SUNDRY NOTICES AND REPORTS ON WELLS

Cactus QN Unit #12

Yates Drilling Company
Cactus Queen Unit #12
Unit J, Section 34-12S-31E
Chaves County, NM
30-005-20963
Sundry attachment
April 8, 2009

Permanent Abandonment of Federal Wells Conditions of Approval

CACTUS QUEEN UNIT #12
(GARNER FED #2)
 Sec 34, T12S-R31E CHAVES CO., NM
 30-005-20963

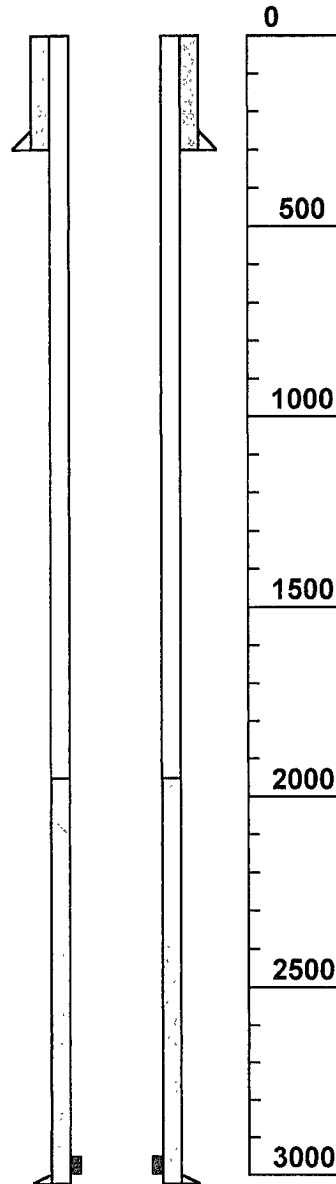
1. Set CIBP @ 2,950', mix and circulate 10# mud inside 5 1/2" casing to surface
- * ~~2.~~ Spot 25 sxs Class "C" cement plug on top of CIBP
- ~~3.~~ Perforate 5 1/2" casing @ 1400'. TOS
4. Set packer @ 1,350'. Mix and circulate 10# mud out 5 1/2" annulus
5. Set cement retainer @ 1,350'. Pump Class "C" cement out of 5 1/2" annulus to surface + 5 sxs. cnt. on top of CIBP.
6. Spot Class "C" cement plug in 5 1/2" casing from 460' to surface
7. Erect dry hole marker, remove equipment and clean location.

* Spot 25 sxs. cnt. @ 2150', BOS.
